To: T10 Technical Committee
 From: Rob Elliott, HP (elliott@hp.com)
 Date: 13 January 2004
 Subject: 03-186r5 SAS-1.1 Transport layer retries

Figure 2 — ST_I (transport layer for SSP initiator ports) state machines

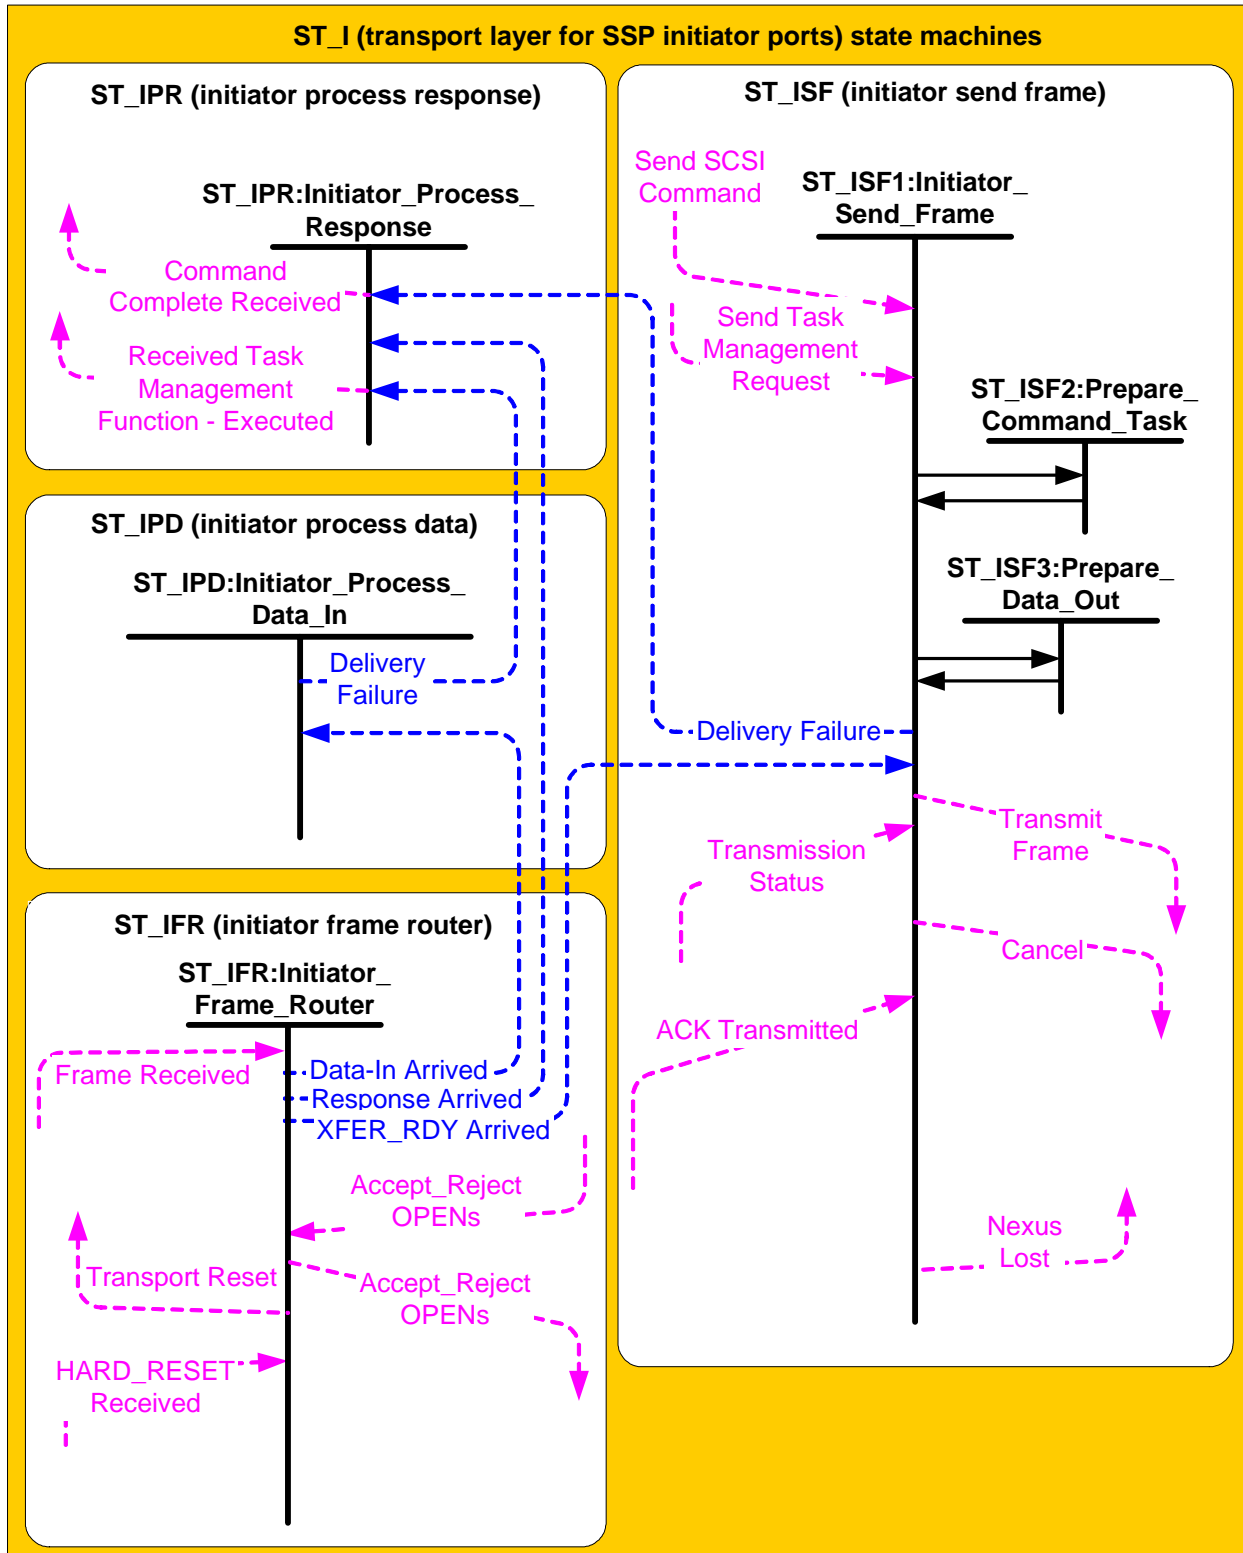
9.2.6 ST (transport layer for SSP ports) state machines [\[modifications throughout\]](#)

Figure 2 shows the ST_I state machines.

Figure 3 — ST_T (transport layer for SSP target ports) state machines

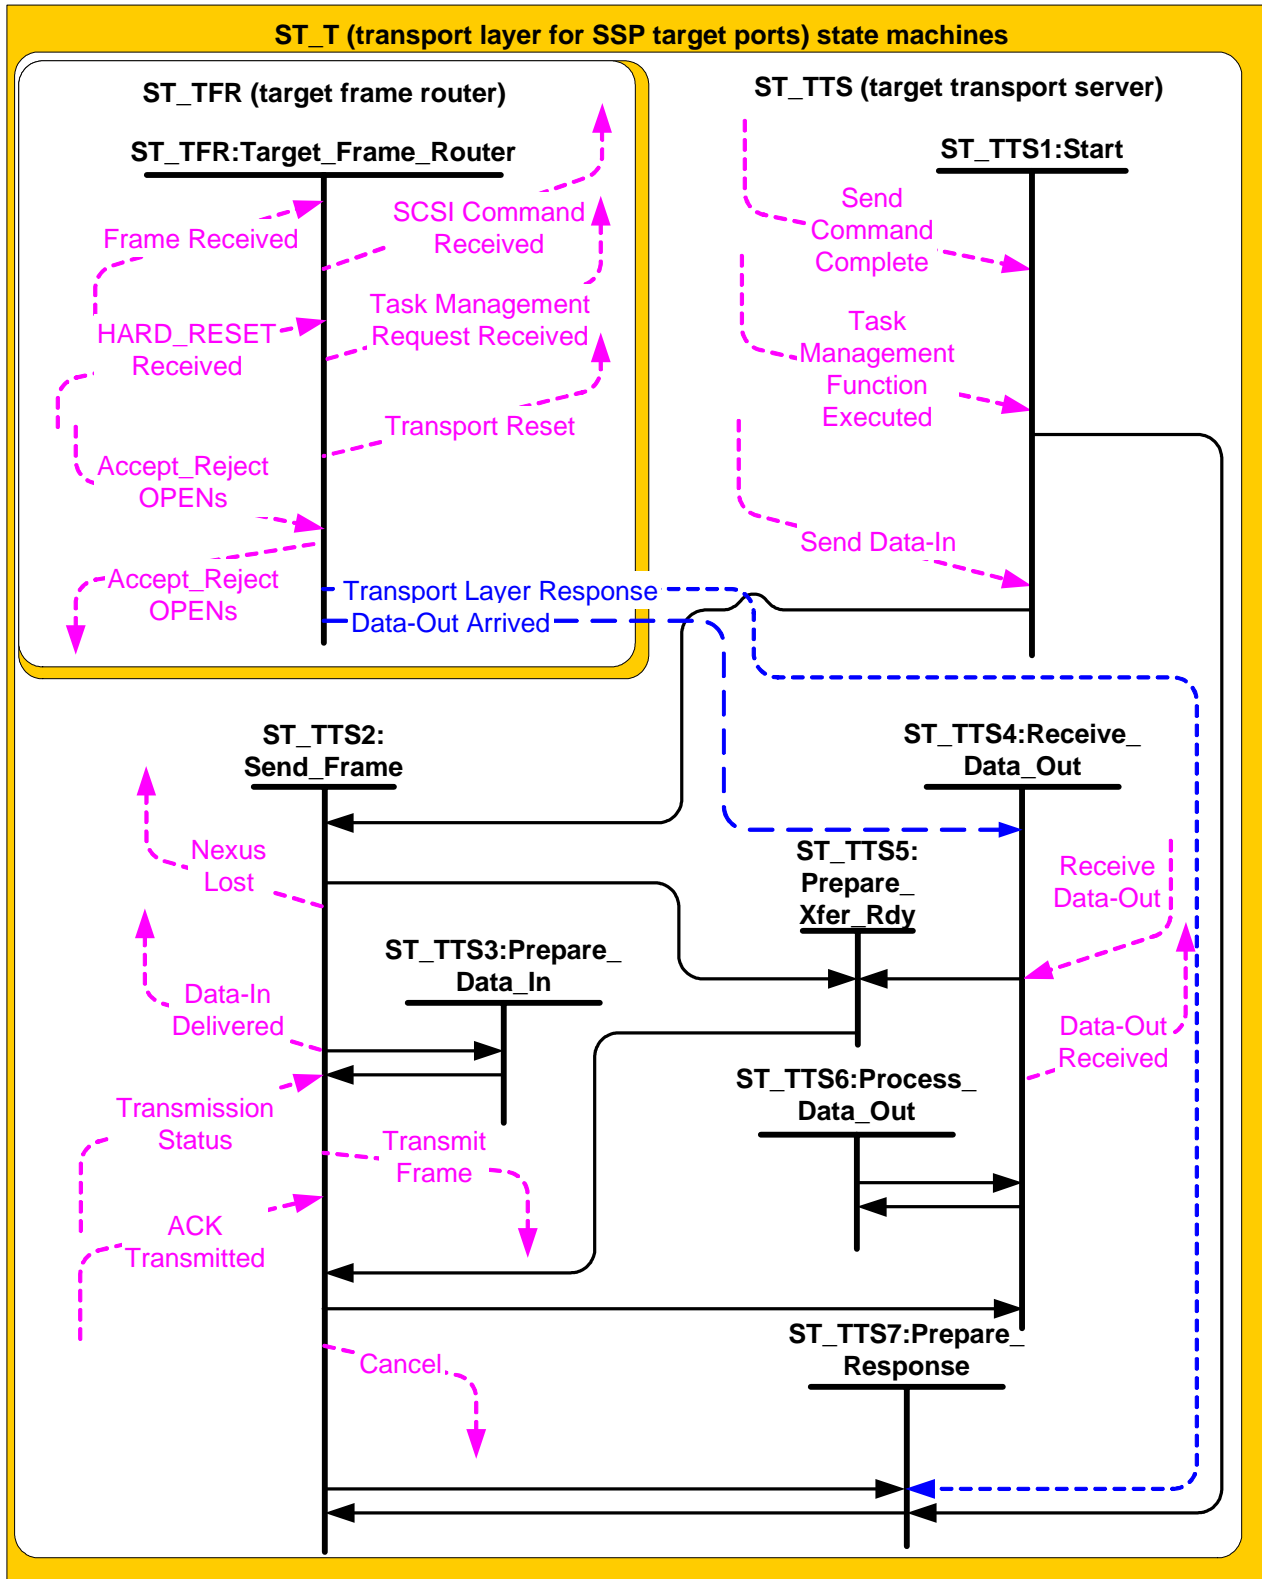
Figure 3 shows the ST_T state machines.
